**PLANNING COMMISSION REPORT**  
**Regular Agenda – Public Hearing Item**

**ITEM NO. 3C: SPECIAL USE PERMIT FOR GAS AND FUEL SALES; 3900 W 29<sup>TH</sup> PLACE (SLD)**

**SUP-7-4-11:** Consider a Special Use Permit for Gas and Fuel Sales and Cleaning (Car Wash), on approximately 2.73 acres of vacant property located at 3900 W 24<sup>th</sup> Place. Submitted by Landplan Engineering, for Corporate Holdings II, LLC, property owner of record, and Hy-Vee, Inc. as contract purchaser.

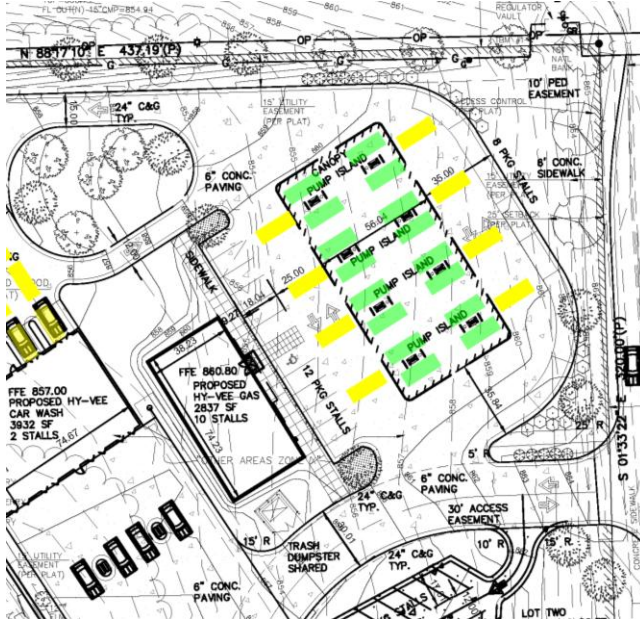
spaces. Gas pumps are required to provide two spaces per pump island. These spaces are generally located either side of the pump. The space between pumps is typically reserved for trash receptacles and windshield cleaning supplies or advertisement signs. It is impractical to provide one space at the end of each island. Staff has interpreted compliance with this standard to be provided at the end of each pumping lane or 8 spaces rather than 16 spaces.

As shown in the image to the left, the required off-street spaces for the gas pumps are shown in green. The required stacking spaces are shown in yellow. In this depiction the stacking space represent vehicles queued waiting to access an available pump. However, they are queued within the two-way drive lane surrounding the fueling area. The site plan shows 8 spaces along the east curb line intended to meet the stacking requirement. This space is more likely to be used as a slip lane around queued vehicles, but is an acceptable design solution given the site's layout and size. The proposed conflict occurs on site, internal to the development, and only during peak times of the day. This may create minor inconveniences for consumers visiting the site for short periods of time, but will not harm any surrounding uses or the community at-large.

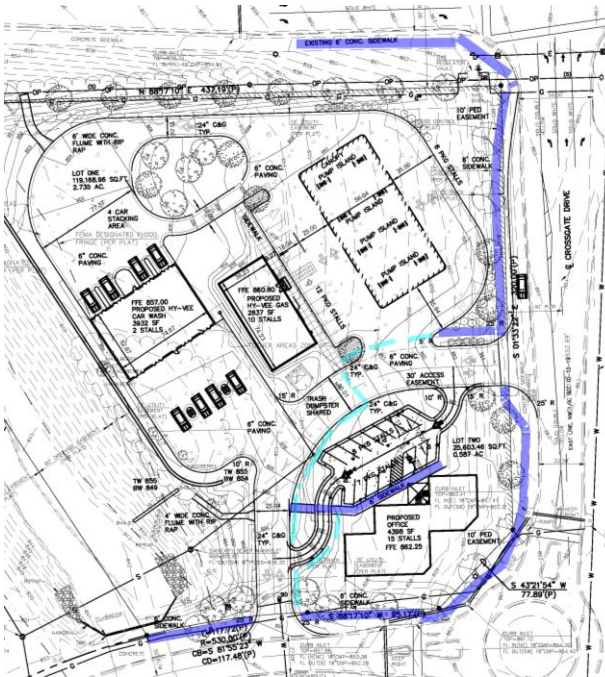
The prototypical building facades do not address minimum design standards and guidelines. The rear and sides of the buildings are shown as blank walls. Four sided architecture treatments are required for the buildings. This site is very open and sits lower than the street elevations meaning that it will be visible from the abutting public streets. Foundation plantings are also recommended.

***Pedestrian accessibility:*** Interior sidewalks are recommended to provide connectivity from the public sidewalks to the interior development. Pavement markings are also needed to accommodate pedestrian crossings within the interior of the development. The dark blue highlighted areas indicate the location of proposed sidewalks. The light blue highlighted areas are recommended pedestrian connections.
